APPENDIX N

N2
RESPONSE TO LA-CITY LEA COMMENTS
SUNSHINE CANYON LANDFILL CITY-COUNTY JTD
FEBRUARY 27, 2008

RE: RESPONSE TO LA-CITY LEA COMMENTS
SUNSHINE CANYON LANDFILL CITY-COUNTY JTD

RE: **RESPONSE TO LA-RWQCB COMMENTS**
SUNSHINE CANYON LANDFILL CITY-COUNTY JTD

FIGURE D-D5

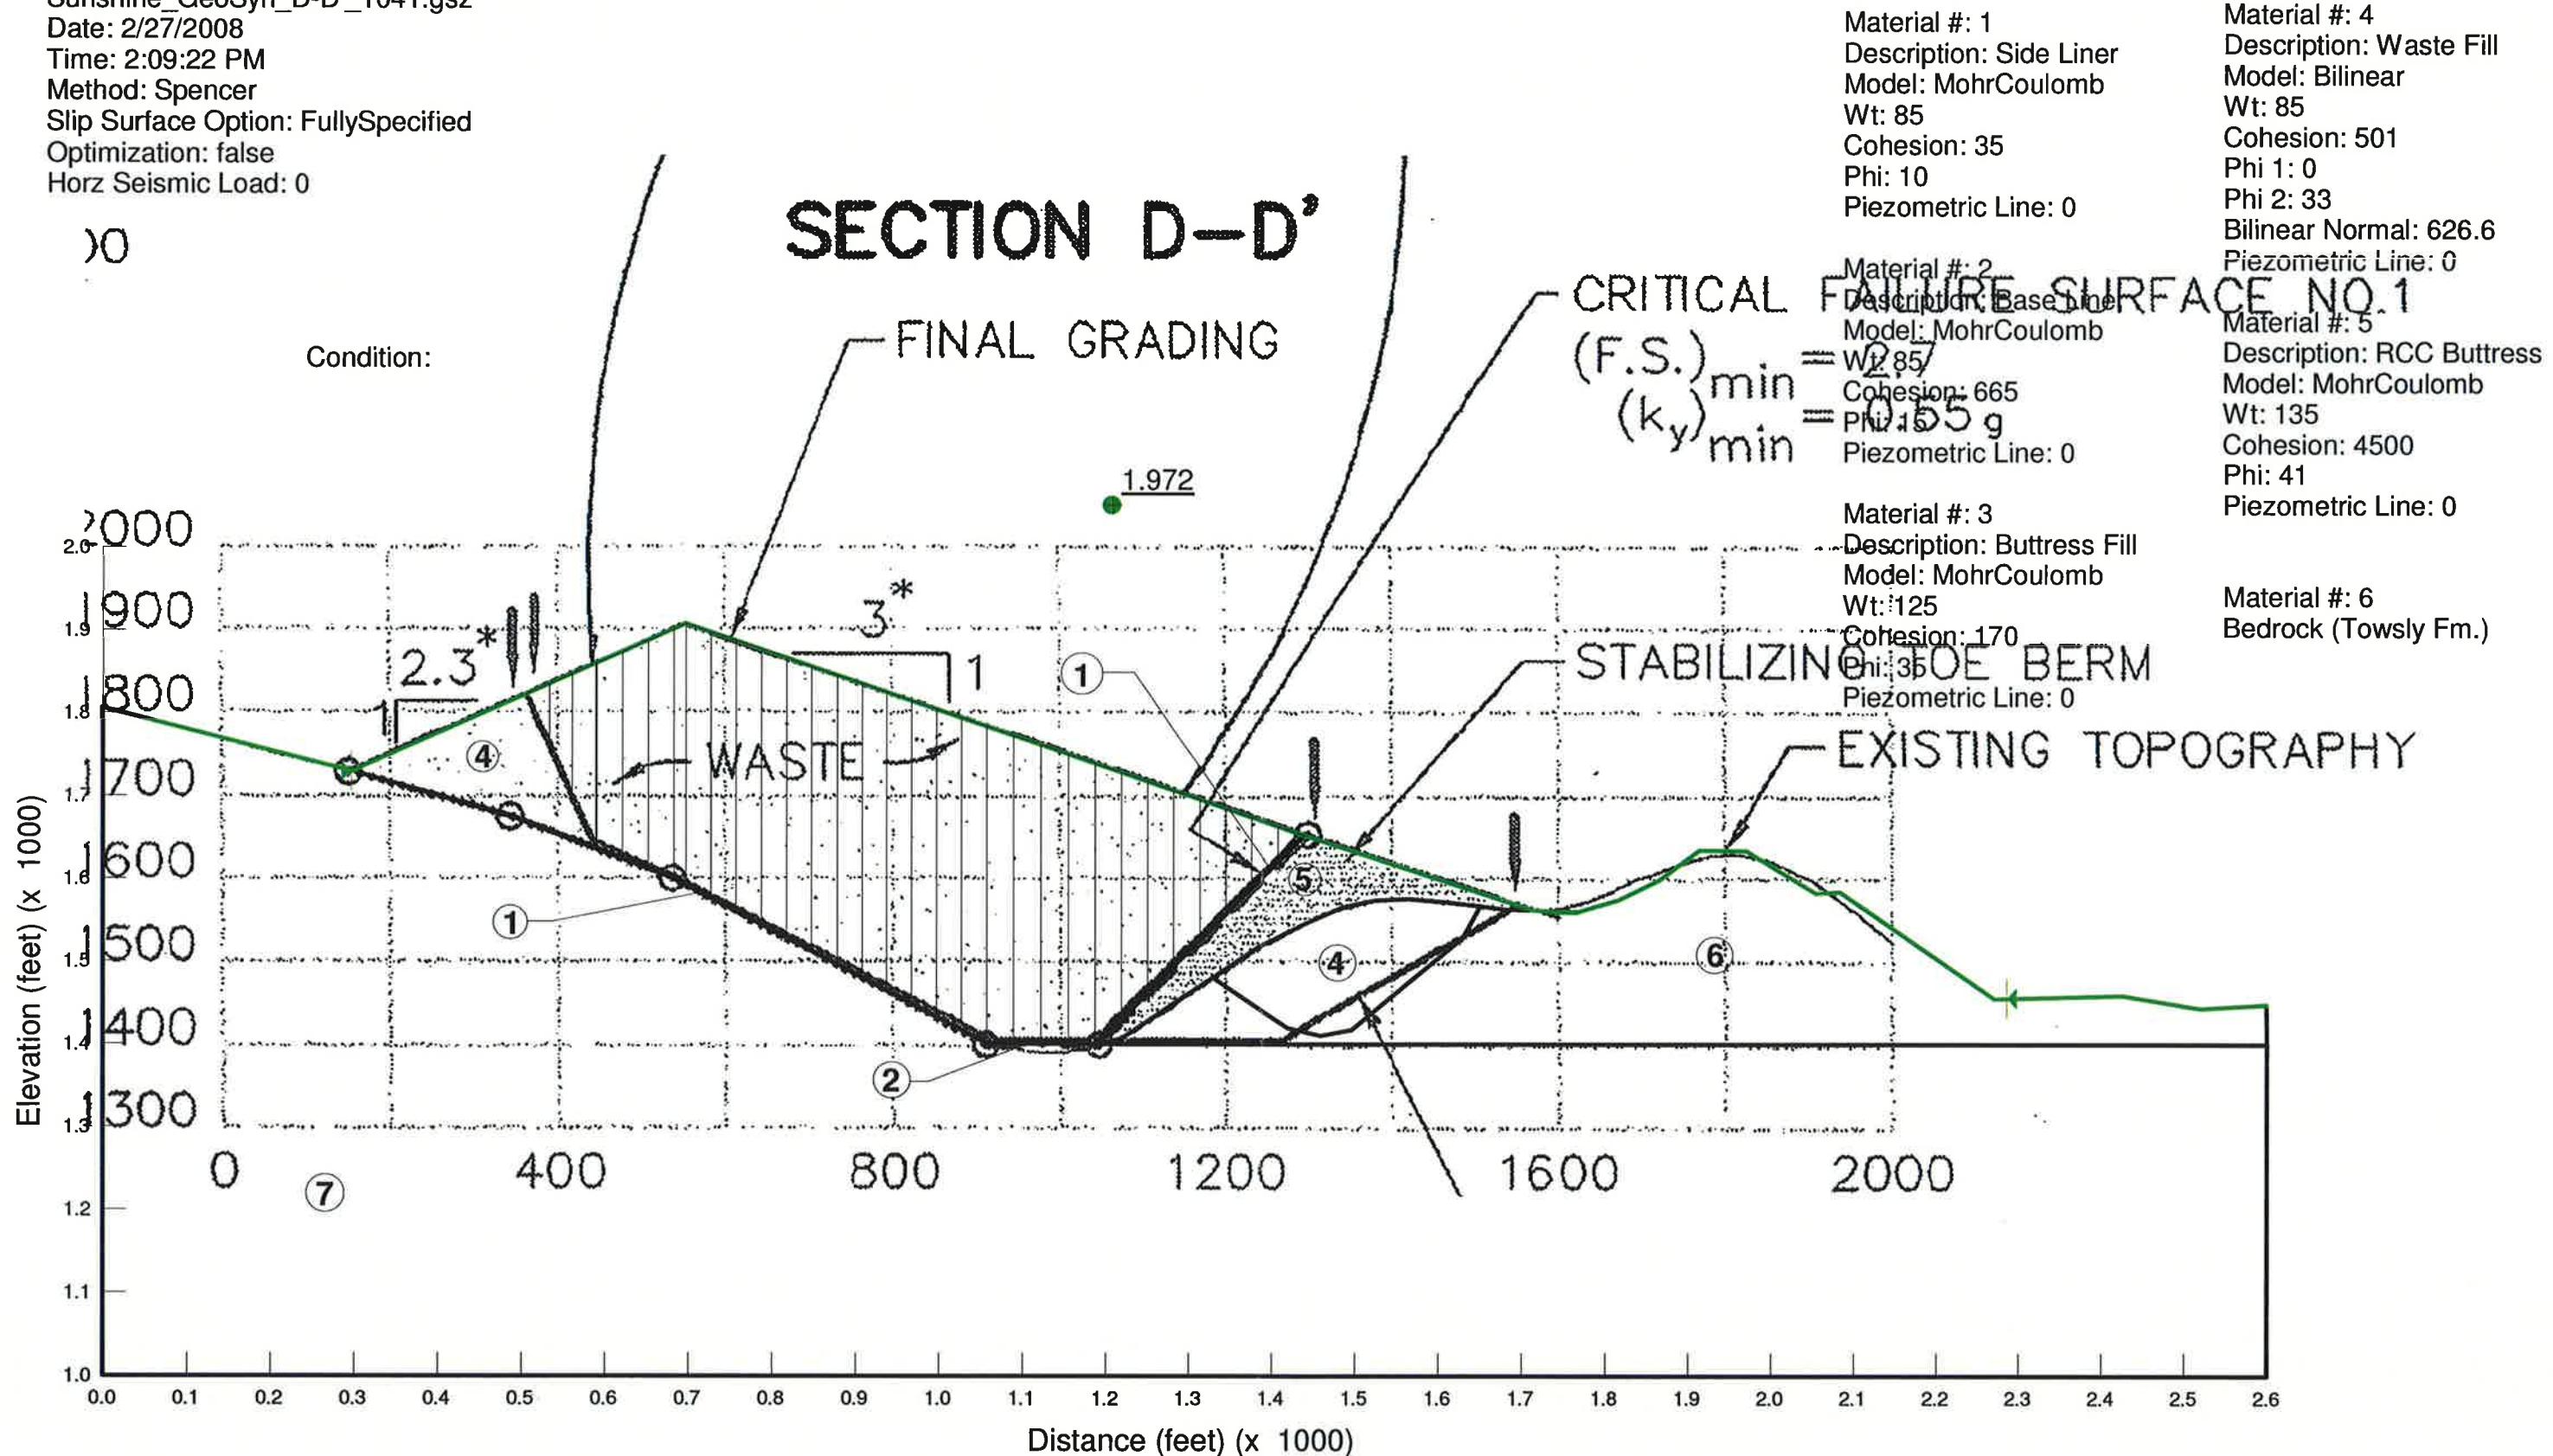
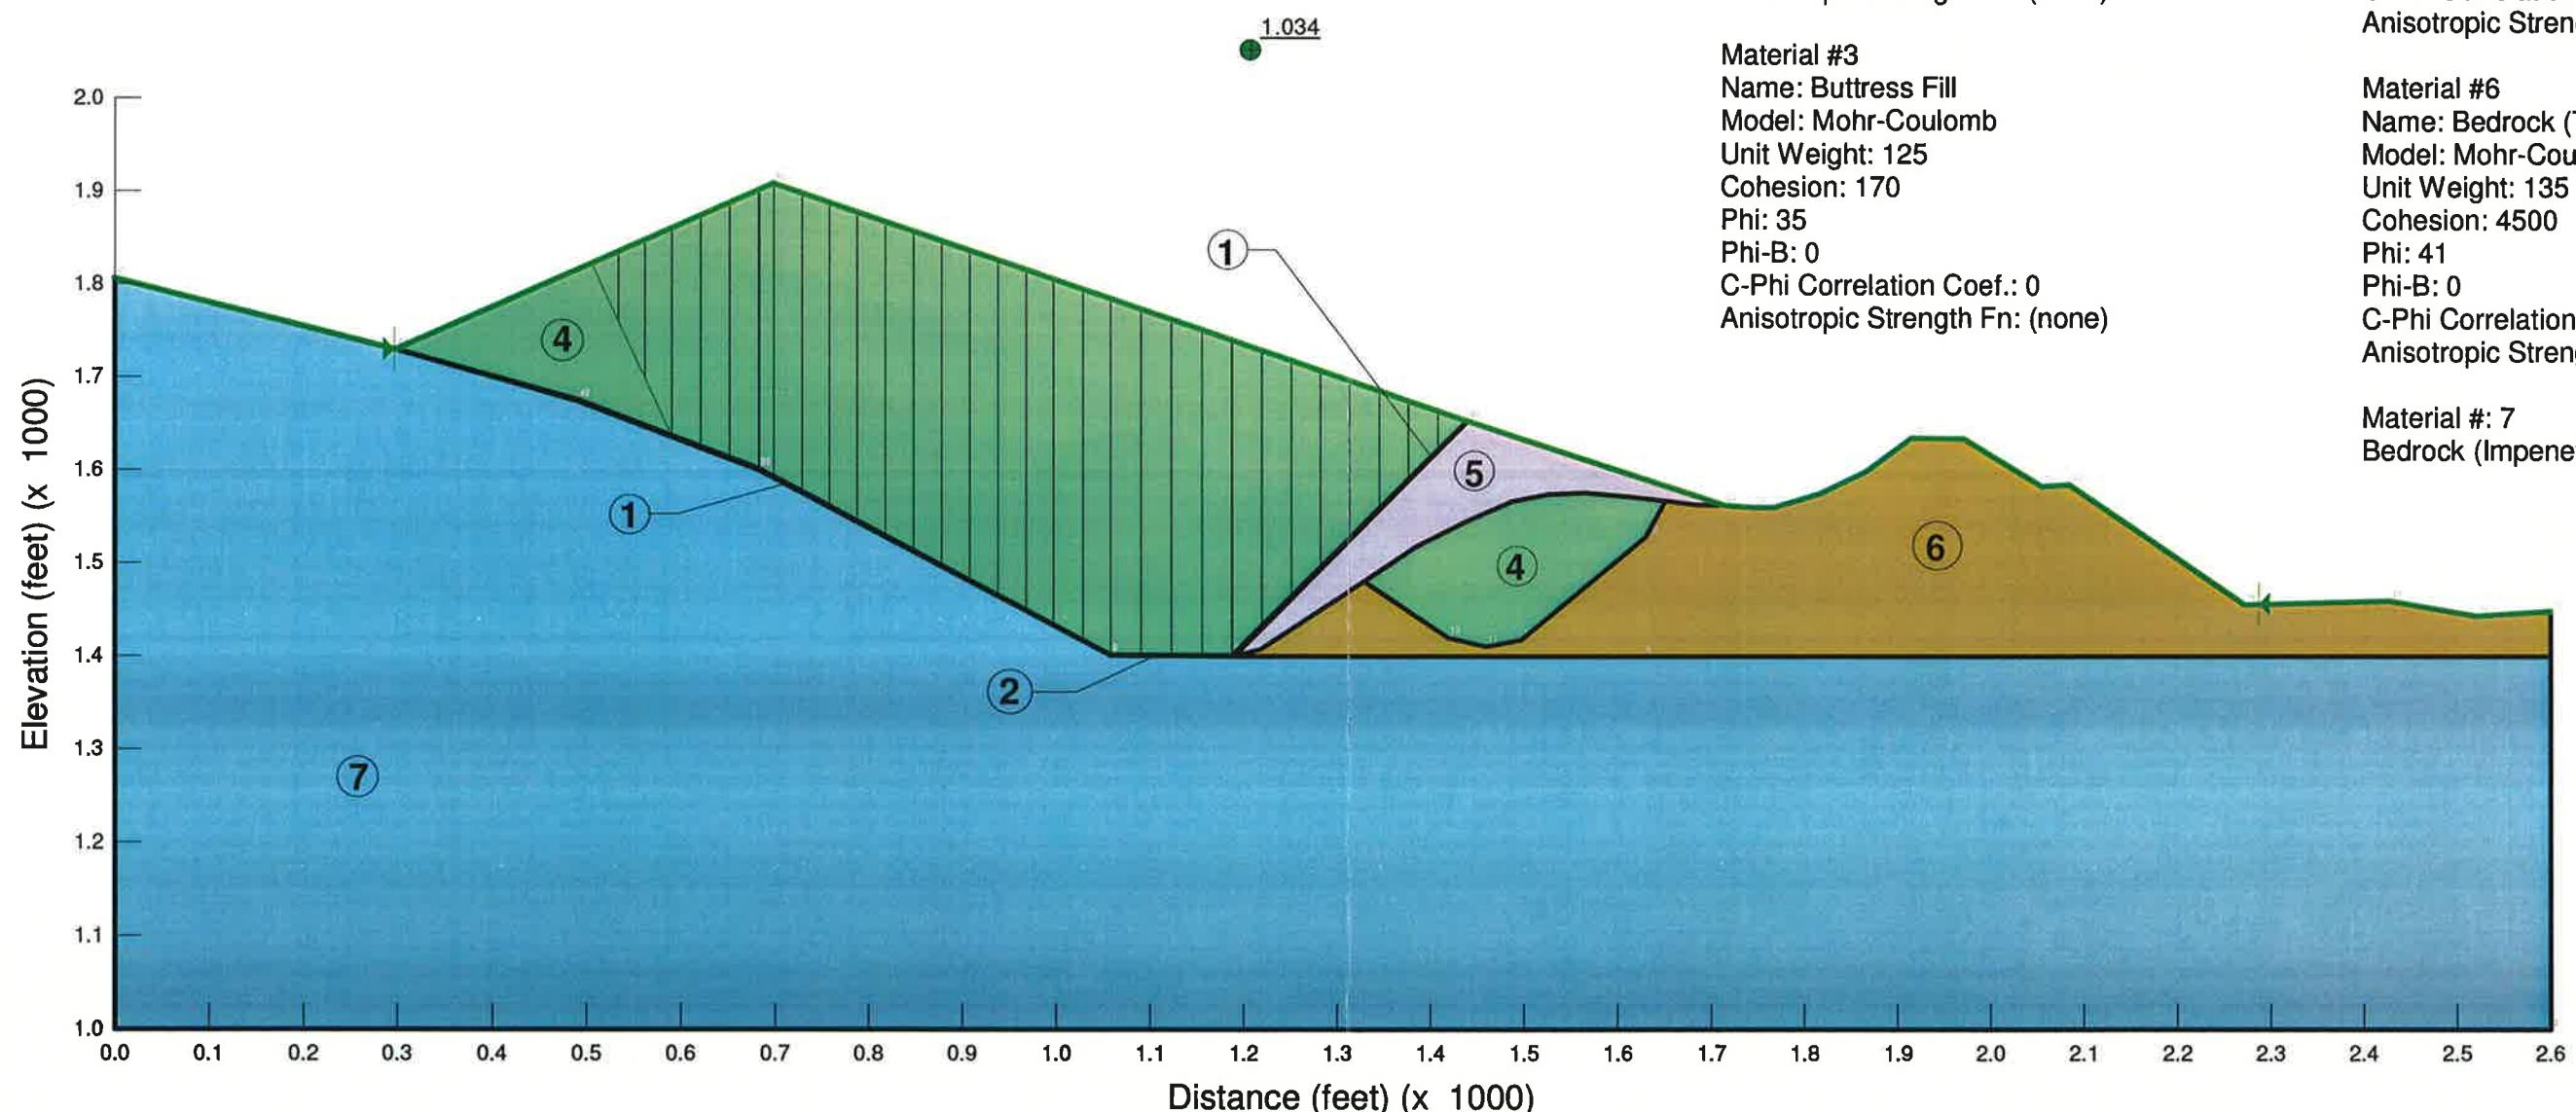
Appendix M, Excavation Slope Stability Analysis and Final Refuse Fill Slopes, Figure 7-6, and Figure 7-7, and Figure 7-8, Section C-C' and Section D-D'; The Section C-C' and Section D-D' slope stability analyses cross section have a stabilizing toe berm which abuts next to "existing topography". The "existing topography" in the area of the previous closed/inactive City Landfill.

Figure 7-7 and Figure 7-8 should show the MSW portion in the cross section depiction. Please differentiate the portions that are soil, and the portions that are MSW. Please also confirm that in the assessment of the slope stability, the modeling took into consideration of the lower density of the MSW at the toe of the proposed landfill expansion."

The newest submission (November 2007, Appendix S) does not have the same slope stability analysis as the previous submission. The current submission's analysis is not applicable to the current proposed expansion. See Figure 13 and Figure 18, and compare to Figure 1a and Figure 1b included in Appendix S (Slope Stability Analysis SCL City) for which the slope stability analysis was performed. The stability analysis was not done on the proposed final contours, and this whole section is inadequate for our analysis and incorrect as written. The current Appendix S is not applicable to the expansion.

Cross Section D-D'

The commenter correctly stated that Cross Section D-D' (Figure 7-8) passes through a portion of the existing inactive City landfill. Based on a comparison of 1987 pre-development topography with the current topography, the extent of existing waste appears to be confined to a northwest-trending canyon which is separated from the access road by bedrock ridge, outcrops of which are currently visible on the surface. As presented in the attached stability analyses for Cross Section D-D', the bedrock ridge interrupts potential failure surfaces that would pass through the existing waste (see Figures D-D1 and D-D2). The static factor of safety for such a potential failure surface is 3.44, and the pseudo-static yield acceleration is greater than 0.67g; note that due to the high value of the actual yield acceleration, the stability analysis software was unable to converge on a solution for seismic coefficients greater than 0.67g (see Figure D-D3).

Recall that in Figure 7-8, the analysis passing through rock at the toe of Cross Section D-D' was the critical analysis, with a static factor of safety of 2.2 and a pseudo-static yield acceleration of 0.28g. Since the results of this analysis were not able to be recreated (and, indeed, the reanalysis proved to be much less critical), the potential liner failure mode was also reanalyzed for Cross Section D-D'. Attached Figures D-D3 to D-D6 present the results of the reanalysis of the liner failure mode; the static factor of safety is 1.97, and the pseudo-static yield acceleration is greater than 0.39g. As above, the stability analysis software was unable to converge on a solution for seismic coefficients

greater than 0.39g, so the actual yield acceleration is greater than this value (see Figure D-D6).

The maximum seismically-induced permanent displacement presented in the 2002 JTD for Cross Section D-D' of about 18 inches was based on a yield acceleration of 0.22g (see Table 7-6). Since the lowest yield acceleration for the reanalyses of Cross Section D-D' presented herein is greater than 0.39g, the estimate of 18 inches of seismically-induced permanent displacement from the 2002 JTD analyses is conservative.

FIGURE 1

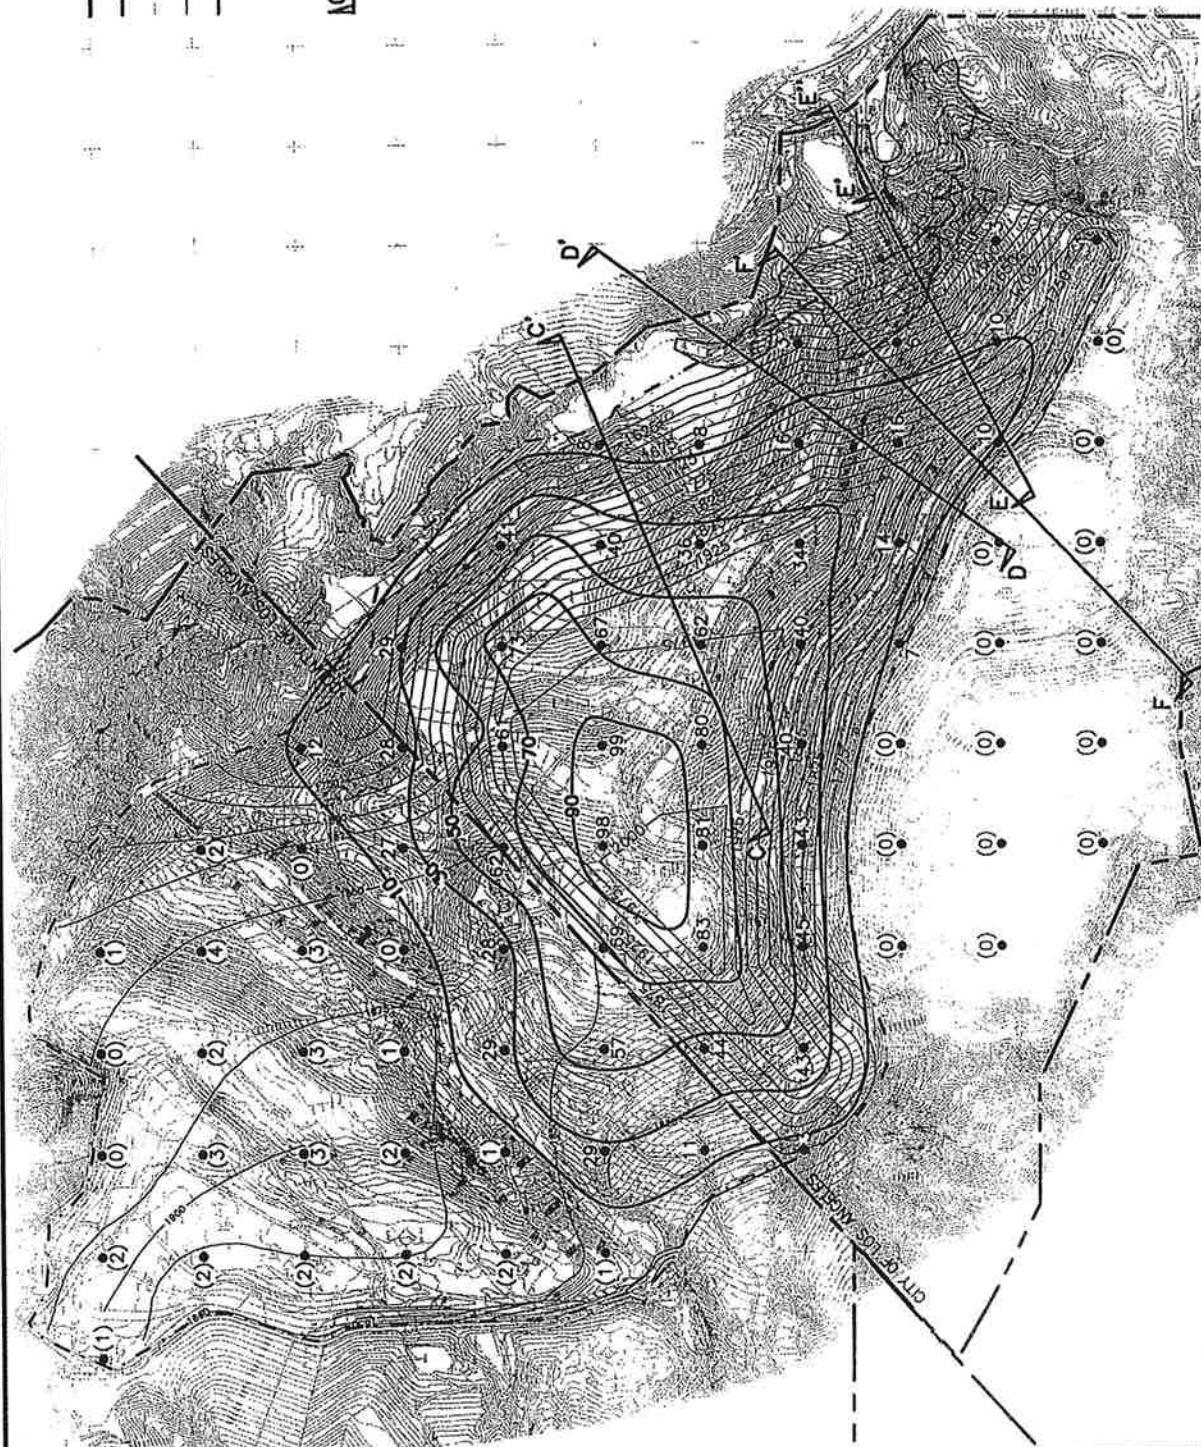
COMMENT 4: - SETTLEMENT ANALYSIS: *Section E.1.4 and Appendix K of the JTD present a settlement analysis for the Landfill after final closure. However, Figure 1 of Appendix K does not show any settlement in the Phase I and II areas of the current County Extension Landfill. We are unclear if this is due to the fact that the iso-settlement contour interval is too great (20 feet) so that smaller settlements could not be displayed, or those areas were not included in the analysis. In either case, the JTD should clarify whether settlement will occur in those areas. Because of the relatively flat final grade in the northern portion of the Landfill, any settlement may affect the surface water drainage system in that area...*

Since much of the waste in the Sunshine County Extension Landfill Phases I and II will have been in place for 20 to 30 years when the new City/County waste is placed, the contribution to remaining settlement after closure in year 2037 from the currently permitted County is expected to be minimal. Regardless, Figure 1 from Appendix K has been revised to include remaining settlement in this area. At the request of the City of Los Angeles LEA, the individual data points used to construct settlement contours in other areas of the site are also presented (see attached revised Figure 1).

Since the southeastern half of the waste-over-waste landfill will be constructed within the next five to ten years (as Phase III of the proposed expansion), the load applied by this waste will have been in place for over 20-years prior to the proposed closure date. This pre-closure loading should pre-consolidate the Old City-Side waste prism and yield a post-closure settlement potential for these materials of no more than 2-5% of their total depth. The northwestern portion of the proposed expansion will load the Old City-Side landfill nearer to the closure date and the maximum residual settlement is estimated to be less than 10% of the total waste depth.

As was noted in the discussion of the waste-over-waste landfill stability presented above, little data exists regarding the actual configuration of the bottom of the Old City-Side landfill. As a result and, similar to the approach used in the stability analyses, potential settlement was estimated by applying the estimated remaining settlement potential at closure (i.e., 2-10%) to the "minimum" waste depth calculated on the basis of the original (USGS) ground configuration. While this analysis is believed to be very conservative, Figure 1 represents the worst-case settlement calculated in this way.
